# BOILER SAFETY REPORT

## Zaber & Zubair Fabrics Ltd

**Factory ID:** 9276

# EXECUTIVE SUMMARY

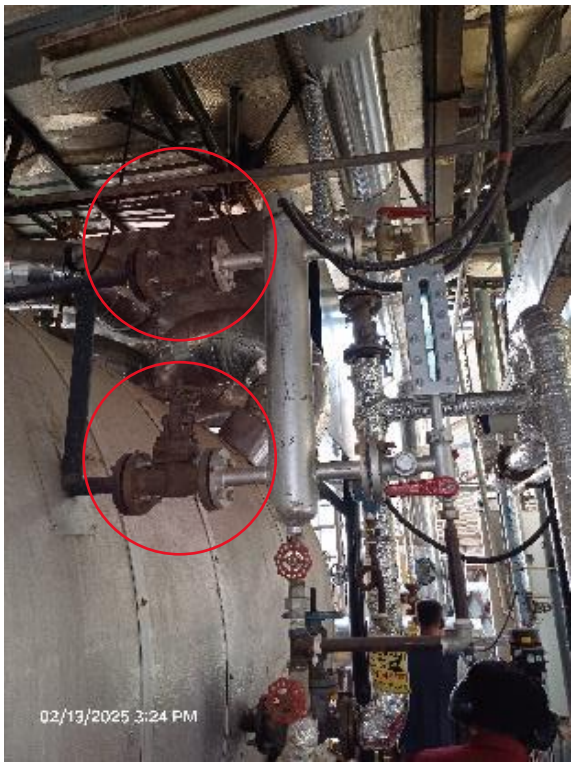
| **RECOMMENDATION:**<br><br>The measuring and sensing devices related to boiler safety shall be mounted directly with the boiler without any valves in between. Any modification shall be consulted with the manufacturer. | |

| **FINDING NO:** | B-80 |

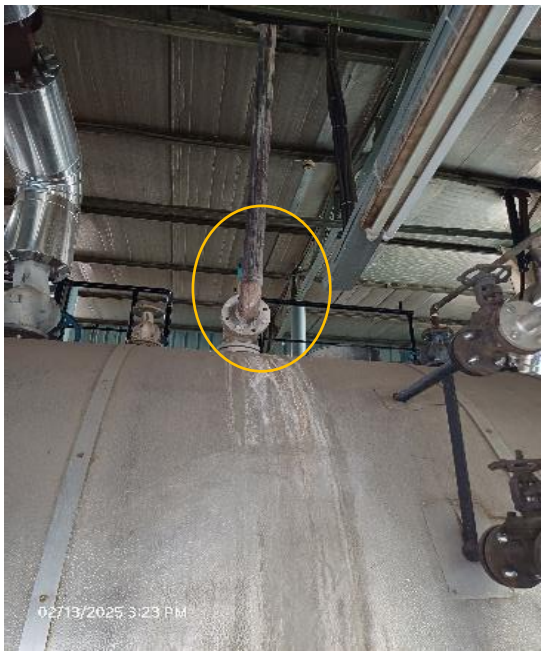
| **CATEGORY:** | SAFETY VALVE |

| **FINDING NO:** | B-81 |

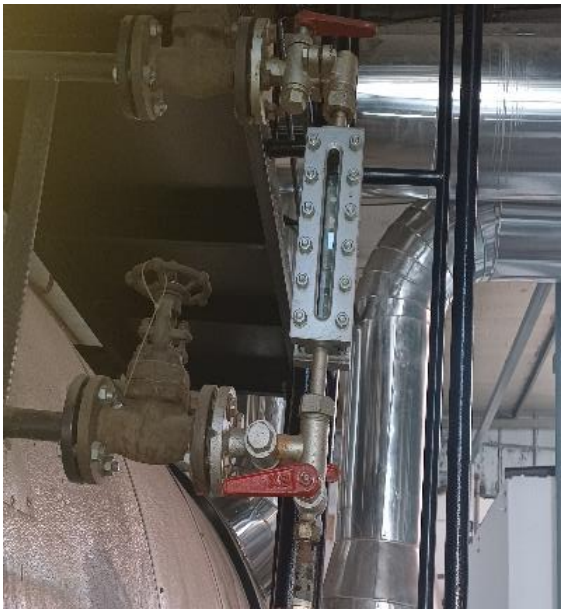
| **CATEGORY:** | MONITORING AND CONTROL SYSTEM |

| **FINDING NO:** | B-87 |  |

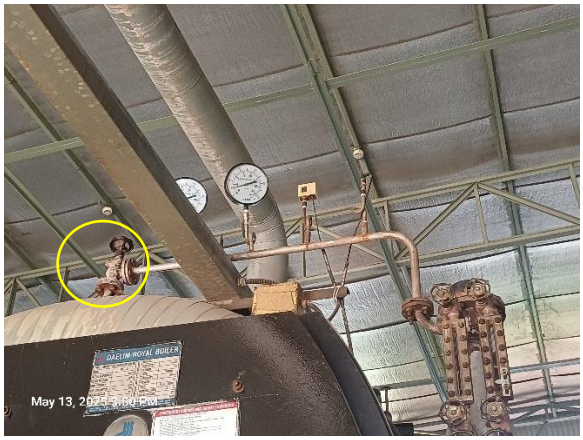
| **CATEGORY:** | MONITORING AND CONTROL SYSTEM | |

| **RECOMMENDATION:**<br>The measuring and sensing devices related to boiler safety shall be mounted directly with the boiler without any valves in between. Any modification shall be consulted with the manufacturer. | | |

| **FINDING NO:** | B-88 |   |

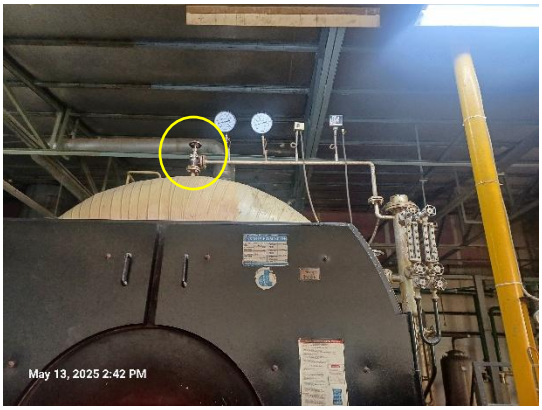
| **CATEGORY:** | MONITORING AND CONTROL SYSTEM | |

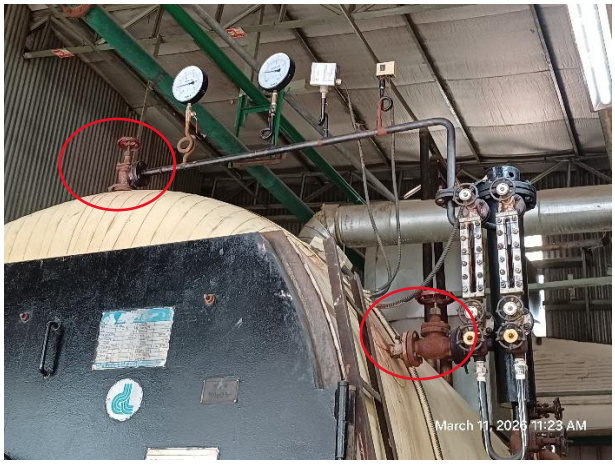
| **RECOMMENDATION:**<br><br>The measuring and sensing devices related to boiler safety shall be mounted directly with the boiler without any valves in between. Any modification shall be consulted with the manufacturer. | |
